# Service Manual

## PERSONAL FACSIMILE

**KX-FT34BR**  
**KX-FT34BR2**  
**KX-FT34BR-G**  
**KX-FT34BR2-G**  
**KX-FT34HK**

### Subject : Parts Change

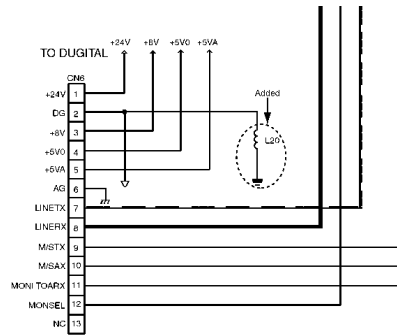
Ref No.	Part No.		Part Name & Descriptions	Pcs	Remarks	Notes		Time of change (Suffix)
	Original Part No.	New Part No.						
CABINET AND ELECTRICAL PARTS								
75	PFUS1091Z	PFUS1091Y	SPRING, STATIC ELECTRIC (A)	1	*a	1	V	
156	PFHX1031Z	PFHS1031Z	SHEET, BRAKE	1		7

Fig. 1

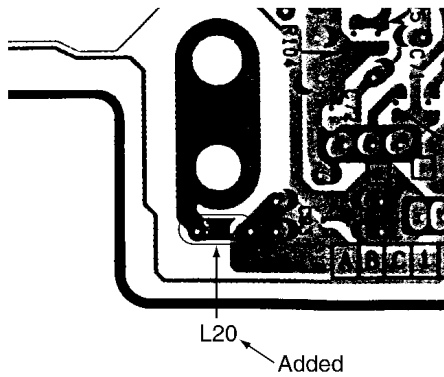
Ref No.	Part No.		Part Name & Descriptions	Pcs	Remarks	Notes		Time of change (Suffix)
	Original Part No.	New Part No.						
CABINET AND ELECTRICAL PARTS								
71	-----	PFGT1666Z-M	NAME PLATE	1		5		
75	PFUS1091Z	PFUS1091Y	SPRING, STATIC ELECTRIC (A)	1	*a	1	V	
156	PFHX1031Z	PFHS1031Z	SHEET, BRAKE	1		7		
ACCESSORIES AND PACKING MATERIALS								
P1	-----	PFPK1791Z-M	GIFT BOX	1		5		
ANALOG BOARD PARTS								
L20	-----	PQLQR1ET	COIL (FERRITE BEAD)	1	*b, Fig.1	5

Change from KX-FT33AL Original Service Manual Order No. KM79807220C3, page 158, section 6/F.
